**RE: 3328 Verdun Avenue**

I visited the site, and reviewed this project initially in February. At that time, I provided comments and recommendations to staff. The current drawings reflect the applicant's changes based on the review comments and recommendations as well as further consultation with staff. My comments and recommendations on the proposed changes are summarized below.

**Current proposed elevation**

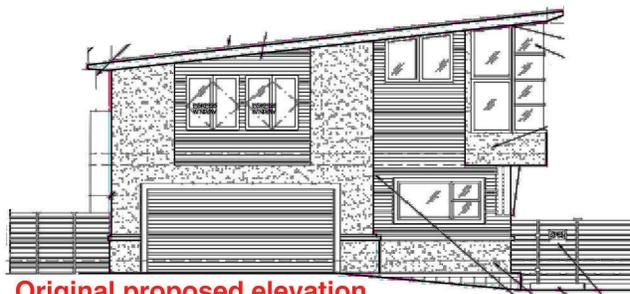
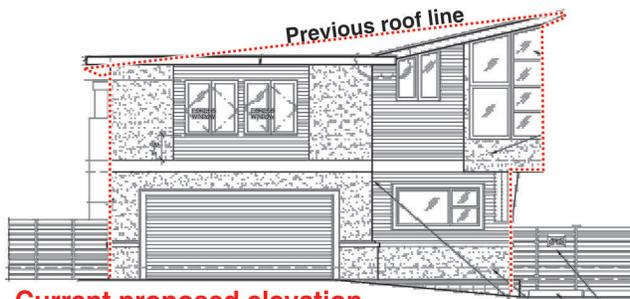
- A modification to the extent of the sloped roof form on the second floor to reduce visual mass seen from the adjacent neighbor, and to better relate to the other nearby homes.
- Breaking up the two-story wall facing Verdun Avenue by the addition of belt trim at the second floor line, a projection of the bedrooms over the first floor facade, and the enhancement of the bay window at the bedrooms;
- Recessing of the garage door to provide greater facade depth.

The applicant has made changes to the design in response to those recommendations. The original and currently proposed front elevations are shown in the diagram below.

While the modified second floor roof form is not exactly the same as recommended, I feel that it is a reasonable solution that I could support.

*Home immediately adjacent to the west*

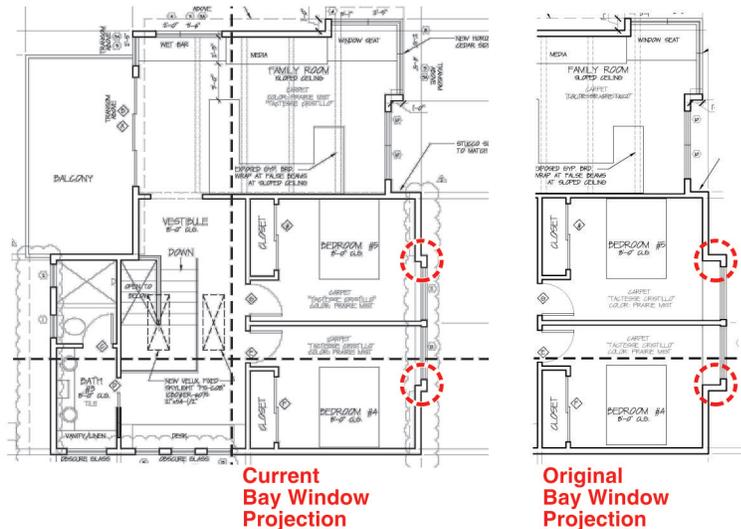
The flat roof form on the west side of the second floor would be similar to the adjacent house to the west, and the added belt trim and overhanging second floor bedrooms would relate well to other nearby homes (see photos below)
